UNITED STATES PATENT AND TRADEMARK OFFICE

10/750,580

Office Action Summary

DETAILED OFFICE ACTION

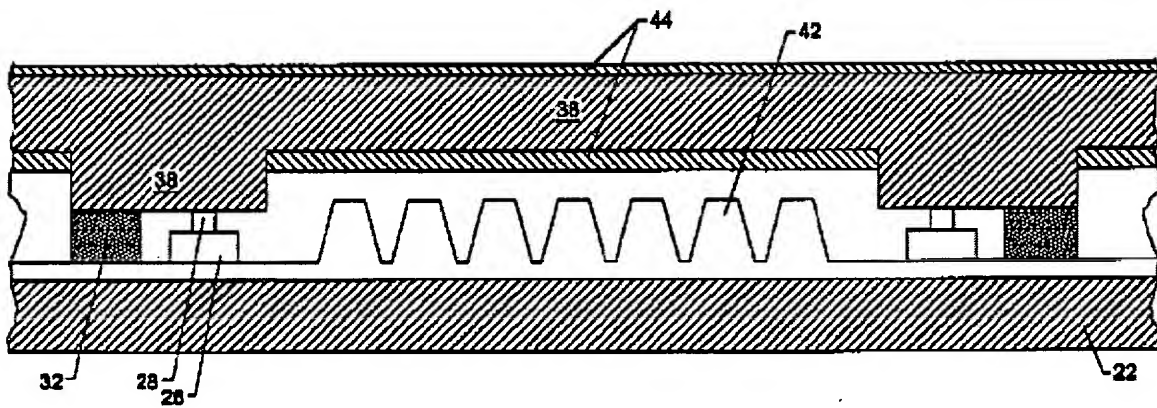
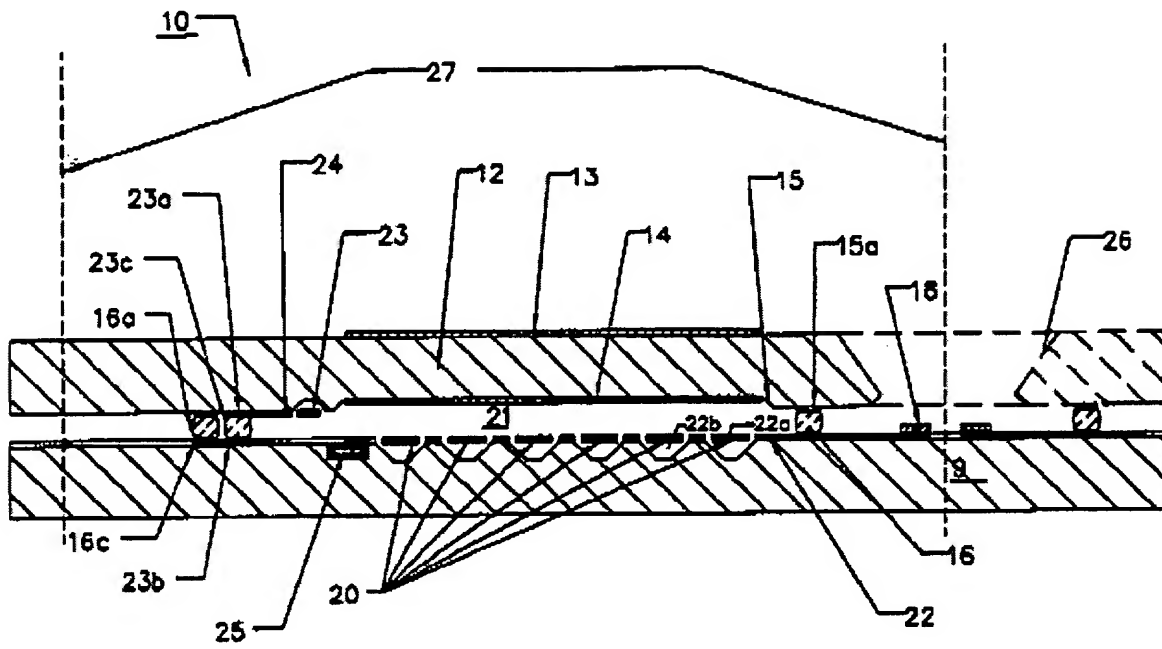
Higashi 233 discloses (in the abstract, in fig 3) an integrated package comprising: a first wafer (fig 3 reference 12) having a first surface; a second wafer (fig 3 reference 9) having a first surface bonded at a first perimeter to the first surface of the first wafer; and a recess formed in the first surface of the first wafer in a second perimeter situated within the first perimeter.

Similarly, Hays et al. (in the abstract, in fig 3, first wafer 38 second wafer 22) disclose the same invention

FIG. 3

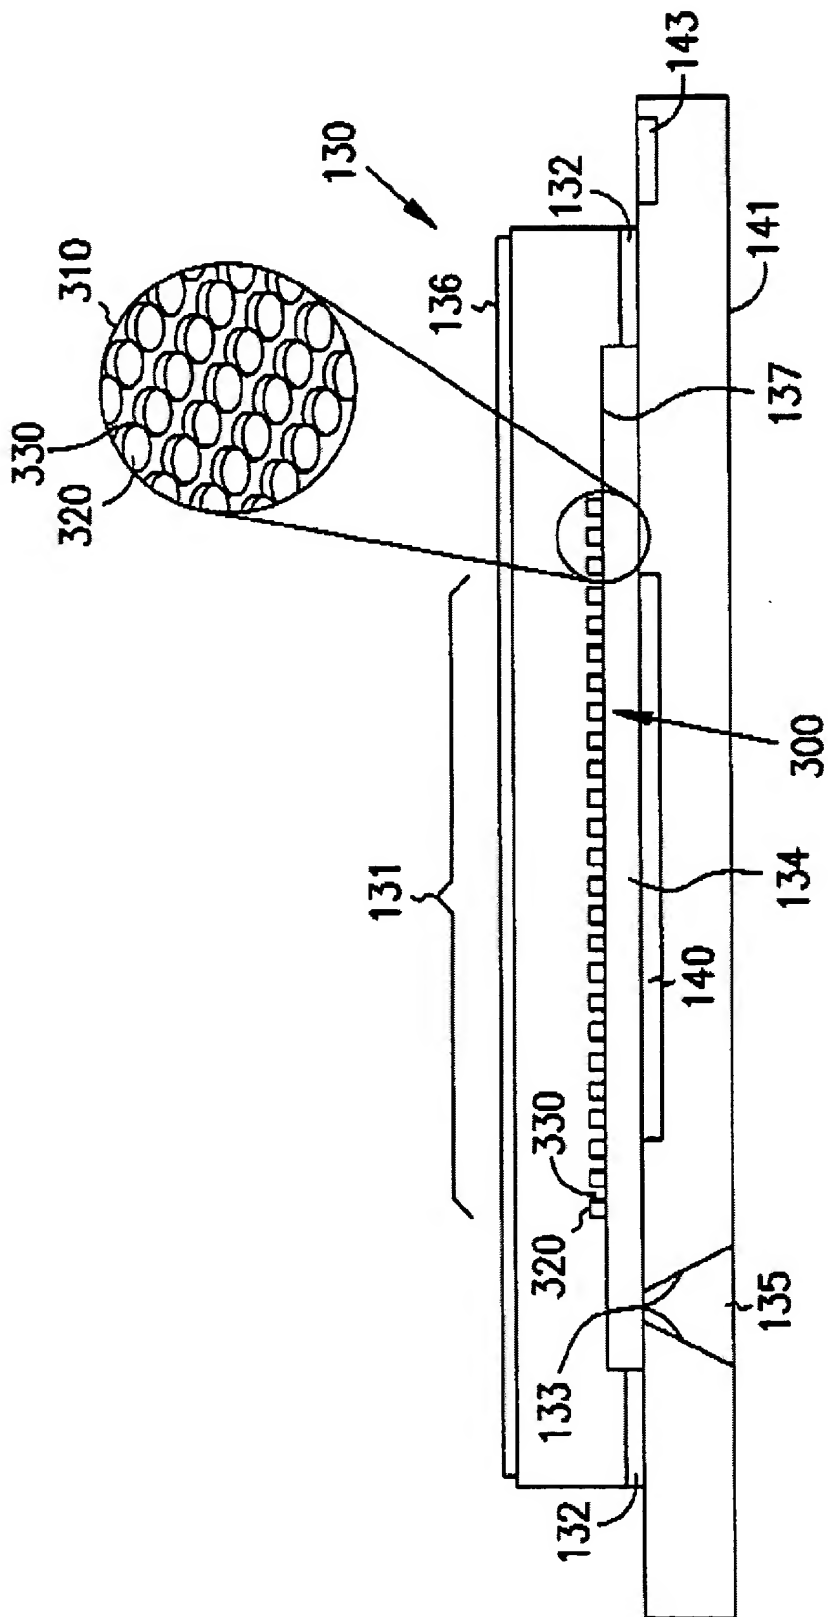
Cole discloses (in the abstract, in fig 3) an integrated package comprising: a first wafer (fig 3 reference 137) having a first surface; a second wafer (fig 3 reference 141) having a first surface bonded at a first perimeter to the first surface of the first wafer; and a recess formed in the first surface of the first wafer in a second perimeter situated within the first perimeter the assembly further comprising a first bump pattern (fig 3 reference 320) in the first surface of the first wafer within the second perimeter.

FIG. 4

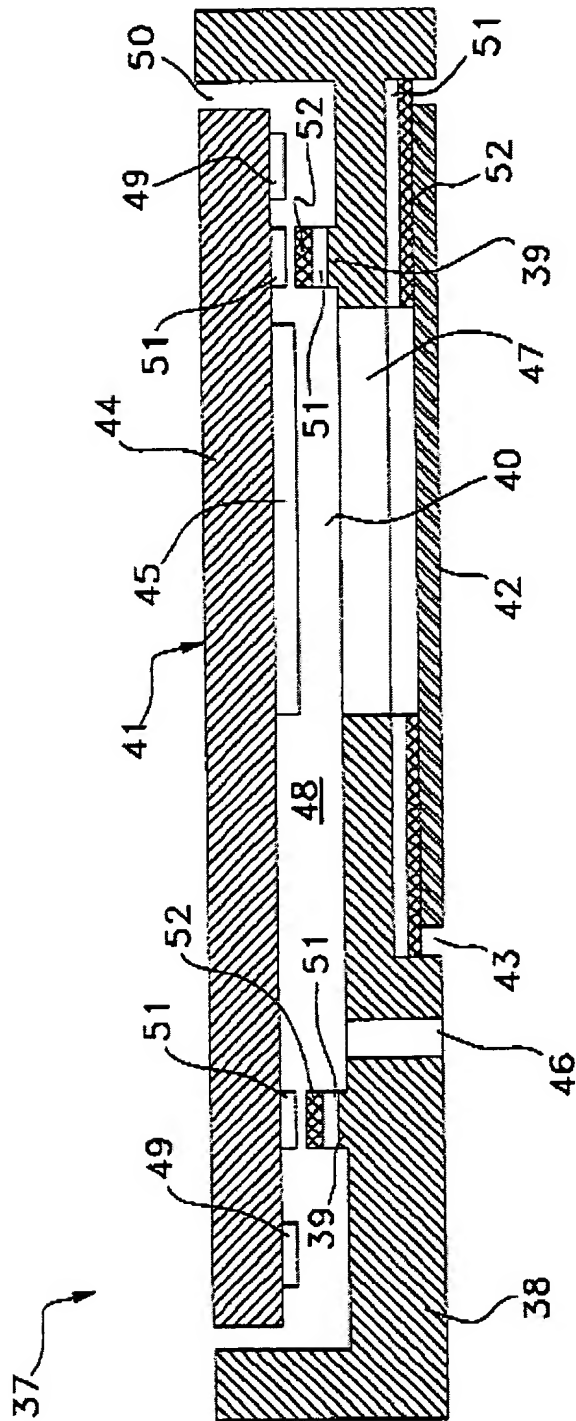
As discussed in the rejection of claim 3 the combined teachings by Higashi 233 and Banish disclose all the invention including a layer of malleable material (Higashi 233 uses solder to seal and solder is malleable) . Missing in the combined teachings by Higashi 233 and Banish is the limitation that the seal have a spacer and bondable material . Jerominek, however, (fig 4 layer 51,52, the abstract) teaches the construction of a package with a seal using spacer and bondable material.

A person skilled in the art at the time the invention was made would have been motivated to further improve the device invented by Higashi 233 and Banish to be less fragile and even more cost effective as suggested by Jerominek in column 1 lines 65-67.
